Docket	:	<u>A.25-07-003</u>
Exhibit Number	:	<u>Cal Adv - #</u>
Commissioner	:	<u>Matthew Baker</u>
Administrative Law Judge	:	<u>Rafael L. Lirag</u>
Public Advocates Office	:	
Witness(es)	:	<u>Justin Menda</u>

REPORT ON NORTHERN DIVISION
PLANT

California American Water Company's
General Rate Case Application 25-07-003
Test Year 2027

Table 1-3: Quail Meadows Well 2 Water Quality Data - Arsenic^{79,80}

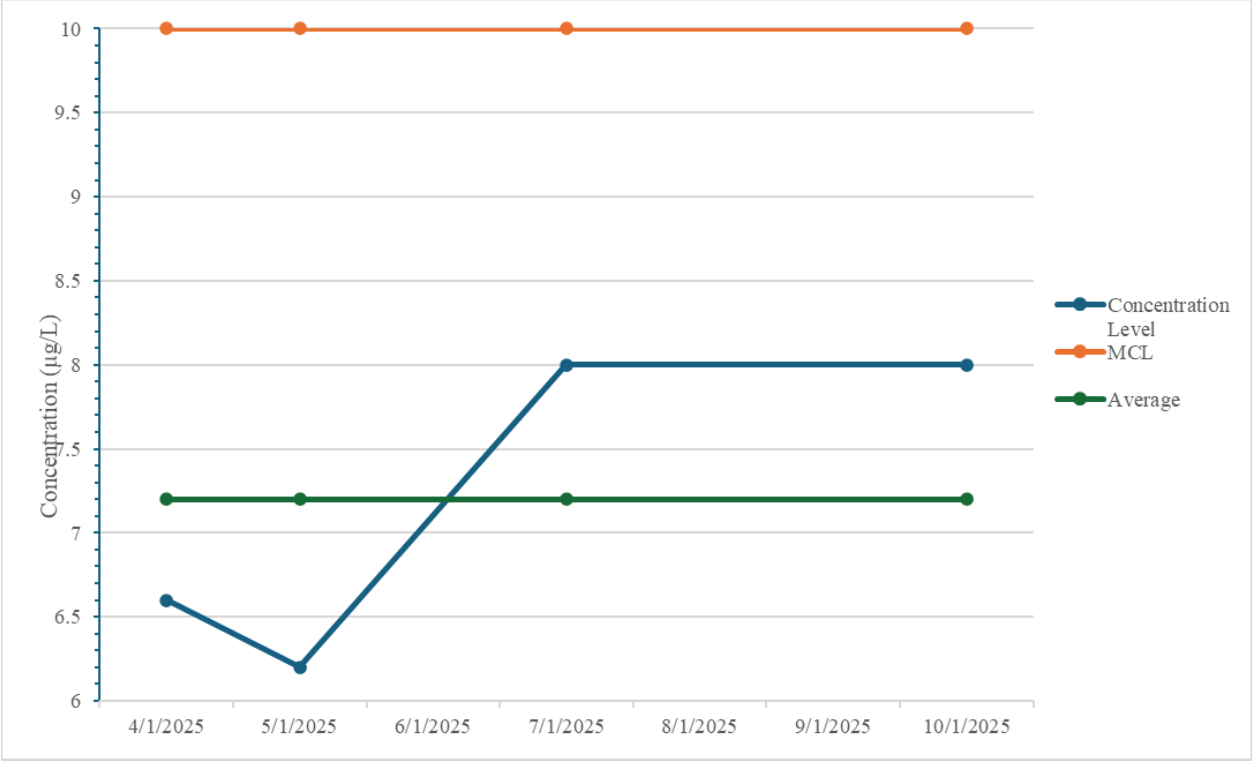
1 Meadows Well 2.⁷⁷ Table 1-3 below displays the arsenic water quality data
2 for Quail Meadows Well 2.⁷⁸

Table 1-3 shows that the arsenic levels at Quail Meadows Well 2 are below the MCL. In addition, Cal Am does not provide any water quality data for PFOA for Quail Meadows Well 2.⁸¹ Therefore, the treatment facility at Quail Meadows 2 is not needed and the treatment facility costs should be removed. Cal Am estimates the treatment facility costs at Quail Meadows Well 2 is \$4,451,000.⁸² The Commission should only allow a budget of \$3,347,107 for I15-600118.^{83,84}
